Criteria for Legacy Name and Code Changes

Date: 03/11/15

Updated: 7/09/18

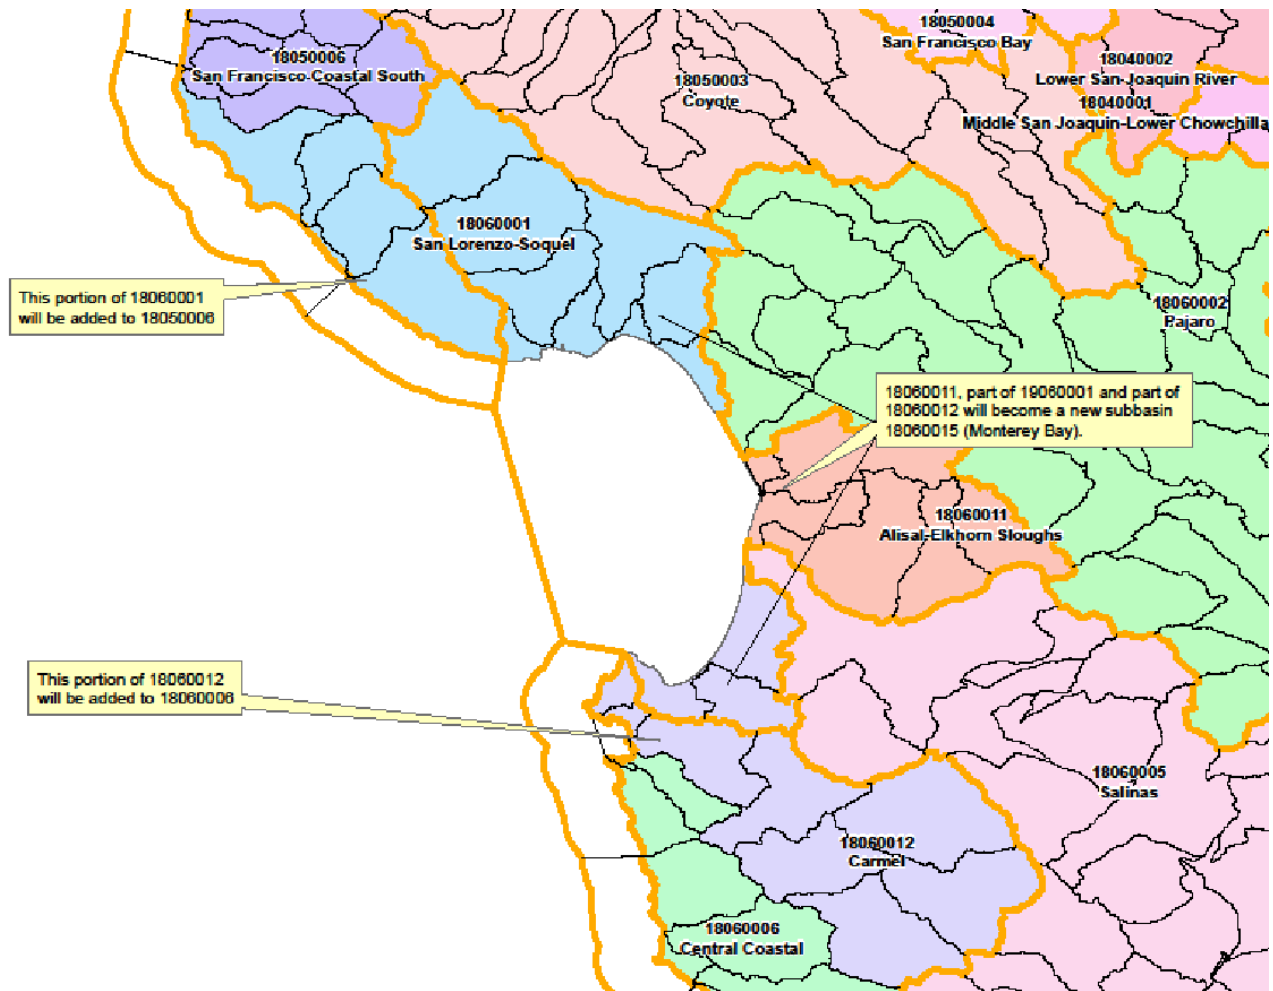
Legacy 18030012 and new 18030012 Tulare-Buena Vista Lakes name should change to Tulare Lake Bed as the boundary has changed so significantly that Buena Vista Lakes are no longer in the adjusted hydrologic unit.

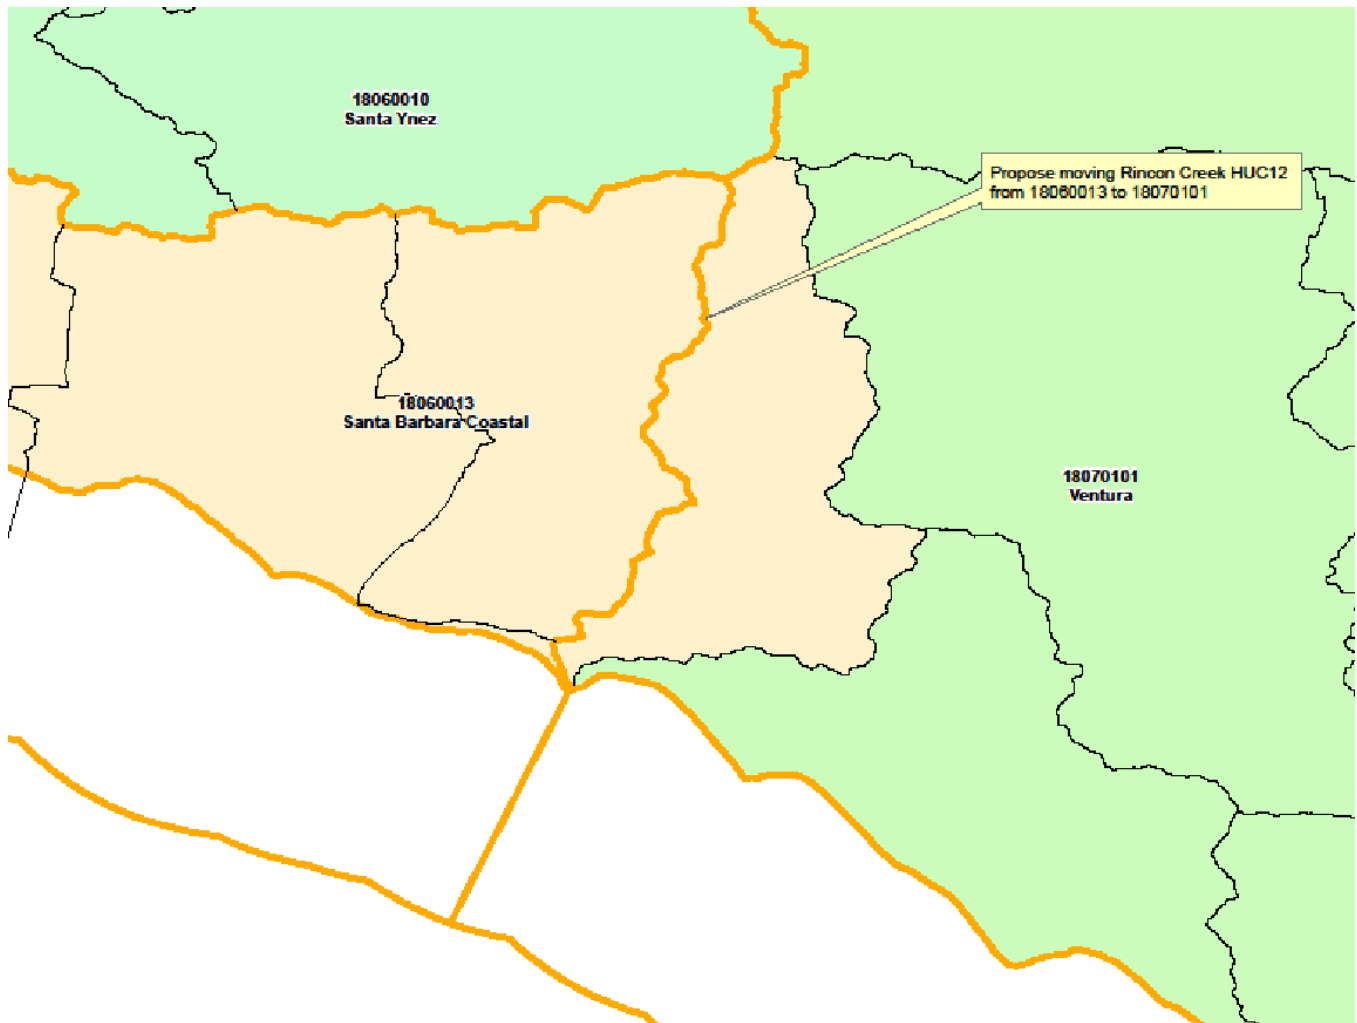
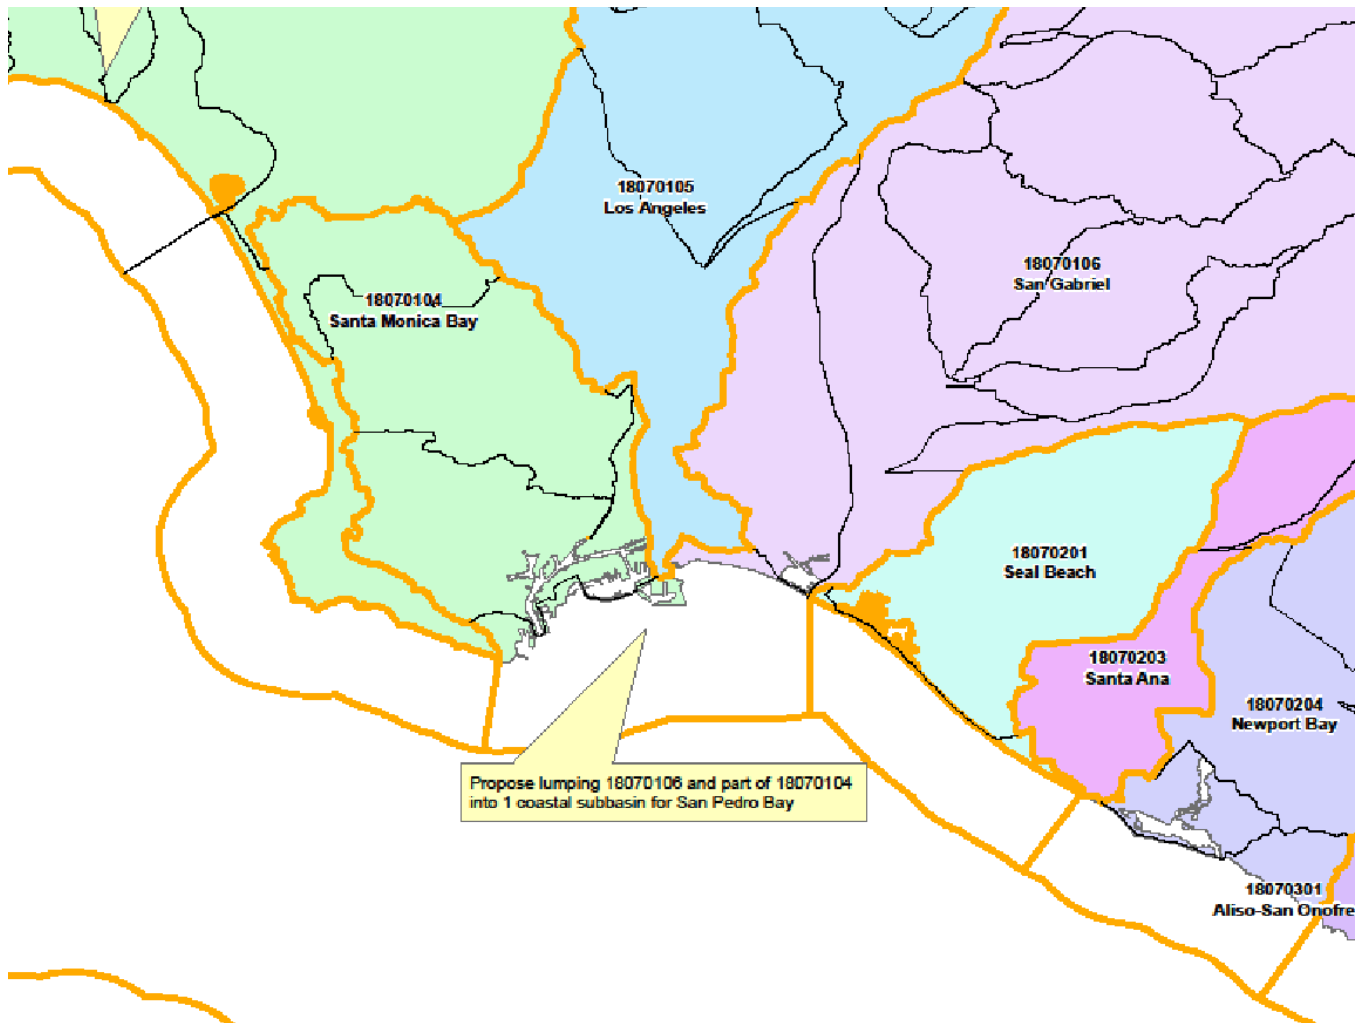
Legacy 18050006 San Francisco-Coastal South will absorb 4 coastal 12-digit HU's from legacy 18060001 San Lorenzo-Soquel as a result of coastal implementation. This is approved by the in-state WBD Steward and the national WBD Technical Team (shown below).

Legacy 18060006 Central Coastal will absorb an area the size of 6 12-digit HU's from legacy 18060012 Carmel which all drains directly to the Pacific Ocean. This is approved by the in-state WBD Steward and the national WBD Technical Team (shown below).

Portions of legacy 18060011, 18060012, and part of 19060001 will become a new subbasin accounting for all of these frontal pieces. It will be coded 18060015 and named Monterey Bay. This is approved by the in-state WBD Steward and the national WBD Technical Team (shown below).

Legacy 18060013 Santa Barbara Coastal had an area the size of one 12-digit HU which will be aggregated with legacy 18070101 Ventura as a result of coastal implementation. This is approved by the in-state WBD Steward and the national WBD Technical Team (shown below).

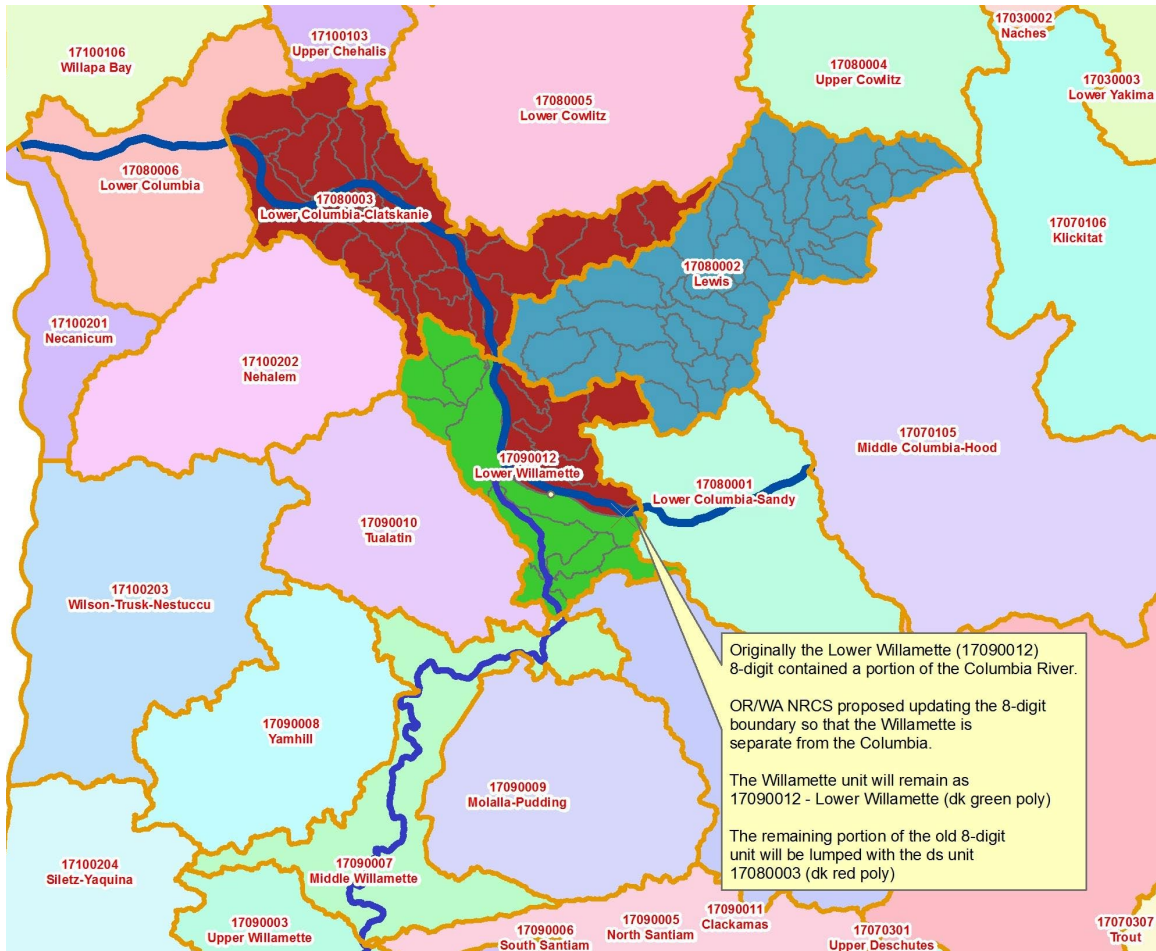
Legacy 17100304 Coos was subdivided into 17100304 Coos to the north and 17100306 Sixes to the south. The Technical team accepts this change.

17090002 and 17080001 will change at the Subregion level this fall when Oregon does updates. The Willamette should never have been lumped with the Lower Columbia.

Result of fall meeting with T3 agreement follows. Determined result for least impact overall.

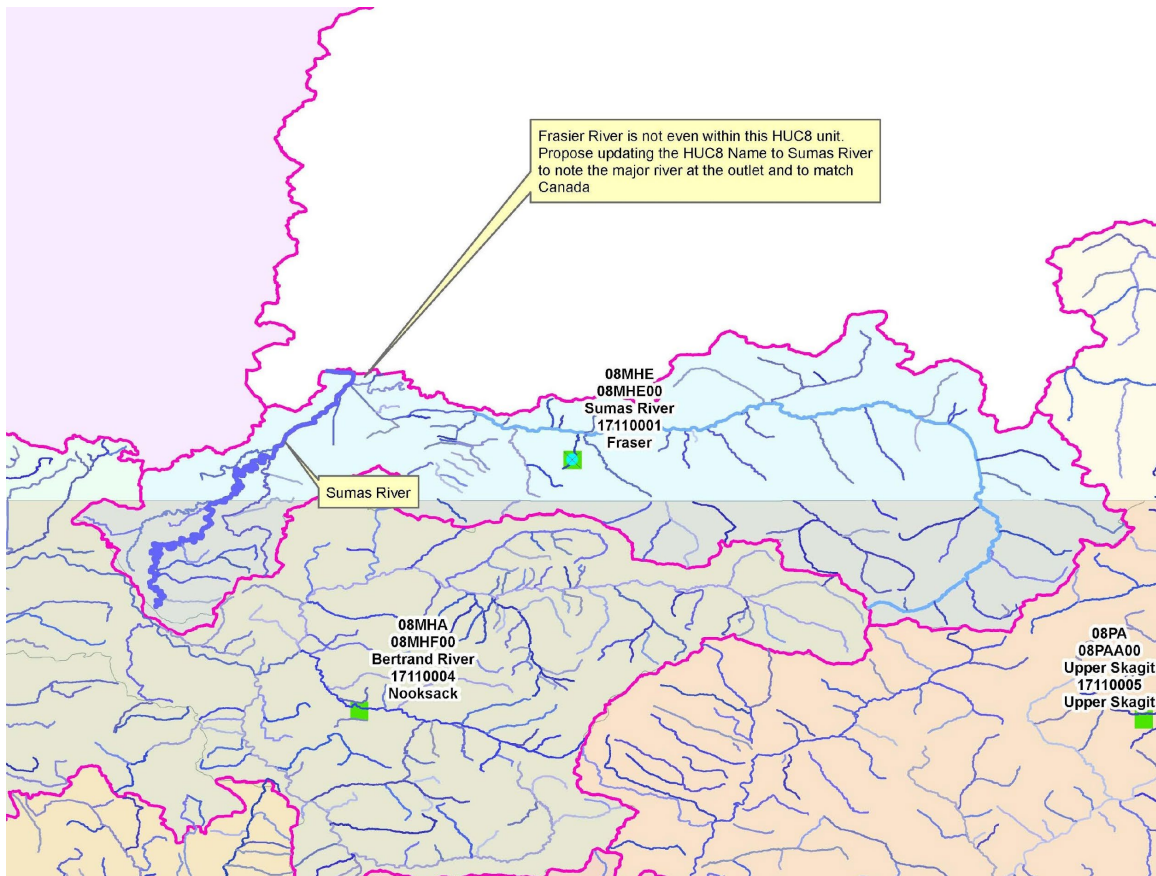
17110001 legacy name "Fraser" is being changed to "Sumas River" to match with Canada, and because the Fraser River doesn't flow through this unit.

Rock Creek

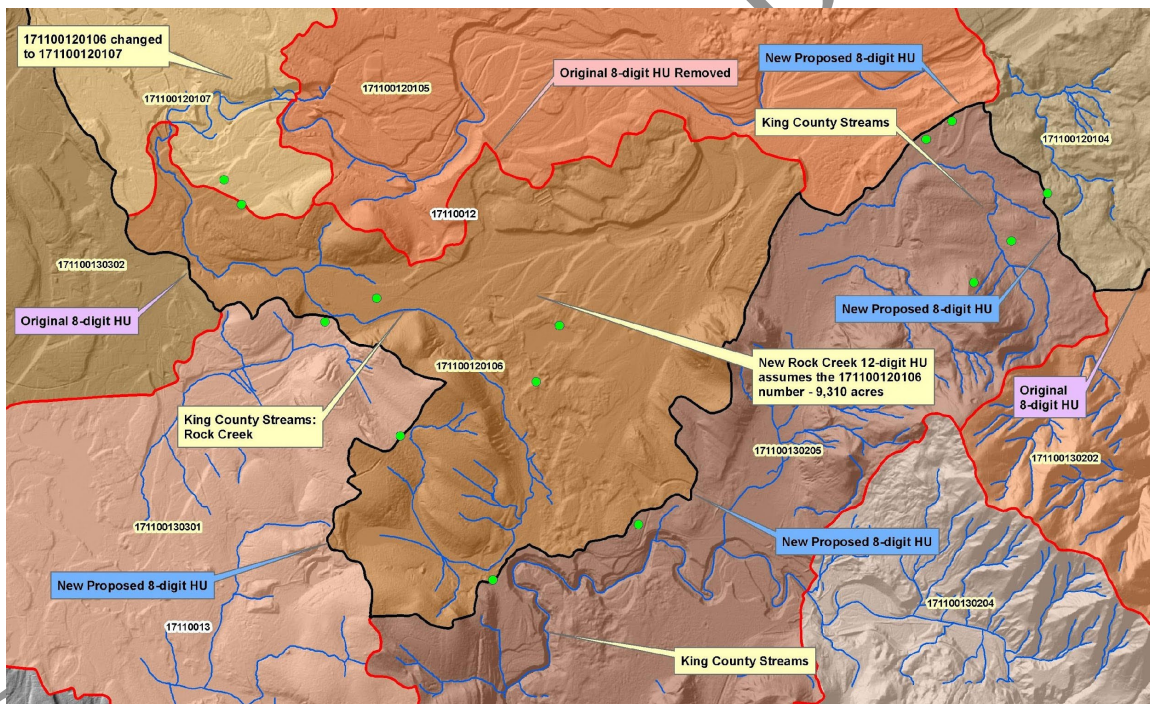
This proposed modification originates from a King County Department of Natural Resources field investigation related to Rock Creek. The information was forwarded to me by Rick Jordan, the NHD State Steward. I reviewed the information and data provided by King County in conjunction with 2009 imagery and LiDAR elevation data (to derive detailed contours and a shaded-relief), and decided that the proposal had merit. I developed a draft WBD boundary that Rick and I reviewed during several NetConferences. Subsequently, we agreed that Rock Creek flows to the north instead of to the west and that the proposed boundary addressed the issue.

This proposed modification changes the 8-digit boundary between 17110012 and 17110013 and creates a new Rock Creek 12-digit unit. The new 12-digit Rock Creek would assume the 171100120106 code, and the downstream 12-digit unit would become 171100120107. Because 171100120107 is the outlet of the 1711001201 10-digit unit, no other unit number is affected.

- The King County investigation, elevation data and existing NHD linework also identified a necessary 8-digit boundary modification for an area coincident between 171100120105 and 171100130205.
- There are several significant modifications to the NHD as a result of this proposal that Rick agrees should be made. The Rock Creek flow will no longer be associated with Ravensdale Creek in the west, or the Green River to the south. There are also several intermittent NHD streams between the new outlet of Rock Creek and the outlet of 171100120105 that are not supported by the topography or imagery and would be removed from the NHD.
- GNIS has a named point for Rock Creek at the outlet of the proposed unit.
- The draft Rock Creek WBD boundaries have been delineated to follow the DRG contours...only using the LiDAR contours as a guide.

Offutt Lake

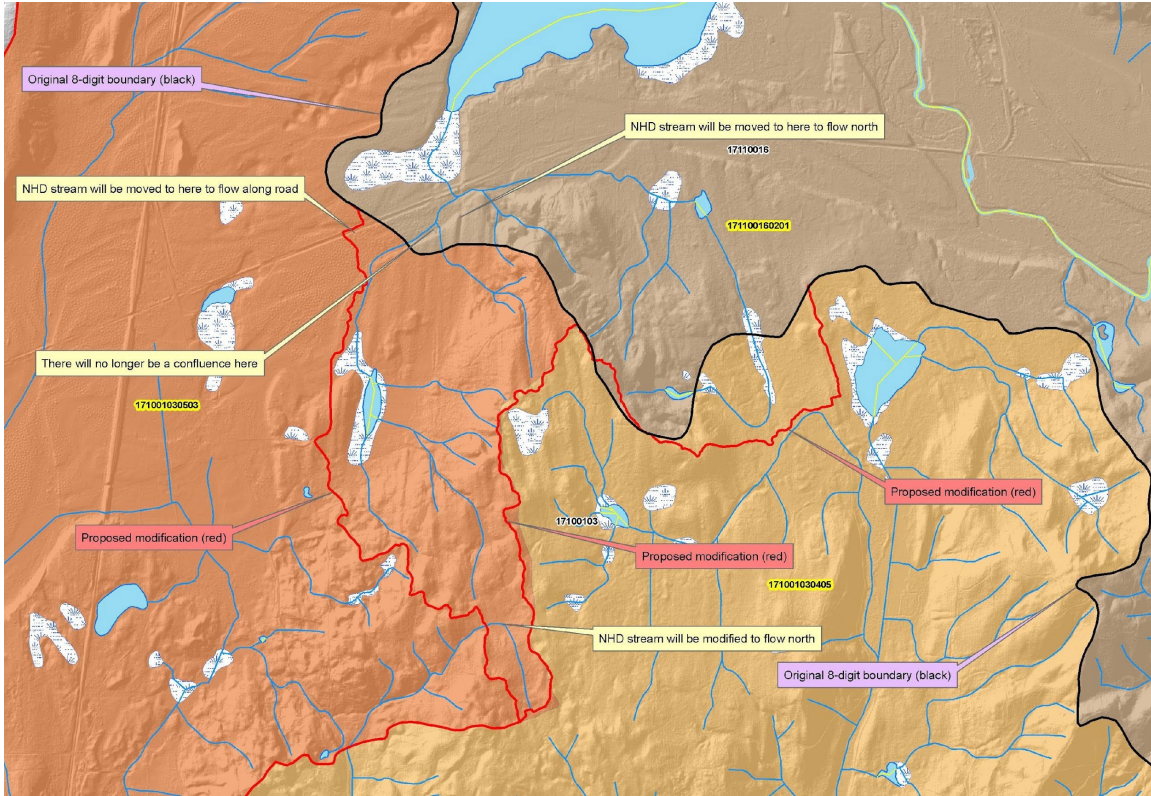
- This proposed modification originates from Rick Jordan's discovery of a conflict between the NHD and WBD. At Rick's request, I reviewed the area utilizing 2009 imagery and a LiDAR elevation dataset (with derived shaded-relief and detailed contours), but because of the nature of the topography I could not make a determination as to whether the NHD was correct or not. I asked one of our NRCS employees who works near this

area if he could investigate and he indicated that he could. I sent him three coordinates and a map and he used a GPS to find these three locations on the ground. He indicated that there is indeed streamflow in the direction that the NHD indicates, which supported the need to make a modification to the WBD.

- This employee's field visit also indicated that the NHD is in error and that it would need to be modified. Similarly, the LiDAR information showed that there were several other places along the proposed boundary where either the current NHD or WBD needed to be modified. Rick and I reviewed these developments during several NetConferences and agreed to the draft WBD boundary and the NHD modifications.

- This WBD modification would change the 8-digit boundary between 17100103 and 17110016. There are no number or name changes.

- The proposed boundary has been delineated following LiDAR contours, not DRG contours, and is therefore at a higher resolution and level of detail.

- The boundary was only modified to account for the change in streamflow in this specific area. Therefore the draft LiDAR-derived boundary is highly detailed until it attaches into the original DRG-derived boundary at either end of the proposed modification. No other part of the WBD was reviewed or modified to a higher resolution beyond these ends because the conflict in the area effected was resolved.
